Town of Mint Hill

Mint Hill Planning Board Agenda November 21st, 2016 at 6:30 p.m.

RE: #S16-17 Mint Hill Commons Preliminary Plat, filed by MHC Land Partners, LLC for 143 Lots; Located at Brighton Park Drive and Steamboat Drive, behind Publix Supermarket; Tax Parcel #s 195-182-31 and 195-182-55

DATE: November 21, 2016

Project: MINT HILL COMMONS
Phase 2
MINT HILL, NORTH CAROLINA
Title: SITE EXHIBIT
File #: 15089-SP.DWG Date: 10/13/16 Project Egr: ABC
Design By: ABC
Drawn By: ABC
Scale: 1"=80'
8720 RED OAK BOULEVARD, SUITE 420
CHARLOTTE, N.C. 28217
PHONE (704) 527-3440 FAX (704) 527-8335
C0.0

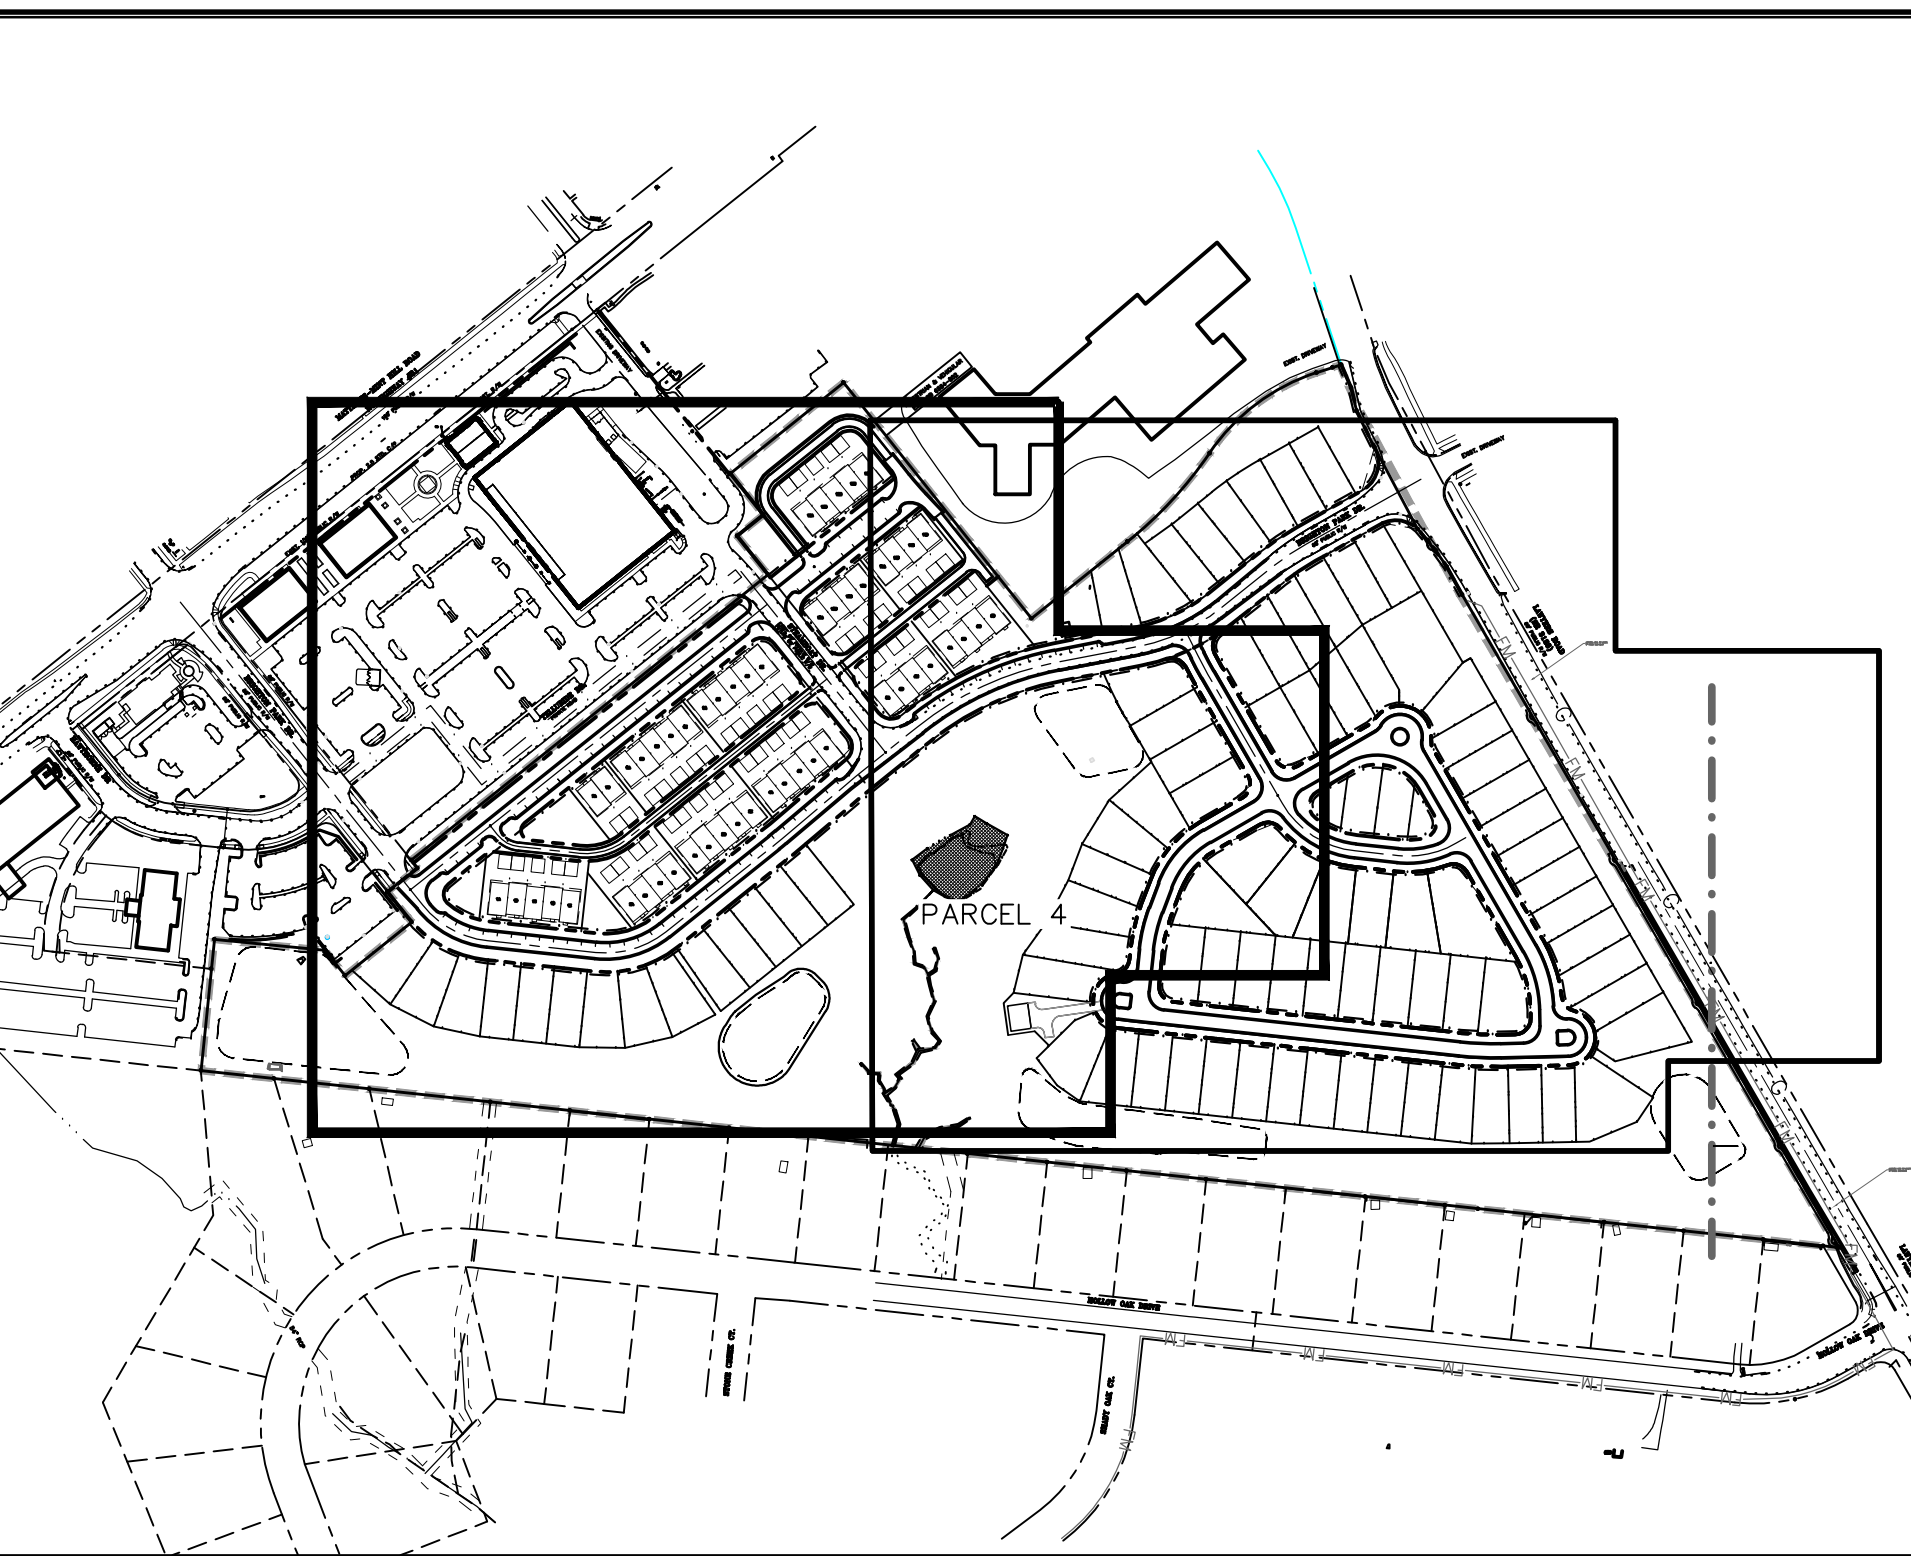
The preliminary plans indicate four different road cross sections (see C0.0). The proposed roadways have been reviewed by staff and appear to meet the appropriate standards. Staff is working with the applicant on installing signage for Alta Lane and Bretton Woods Drive to restrict on-street parking to one side.
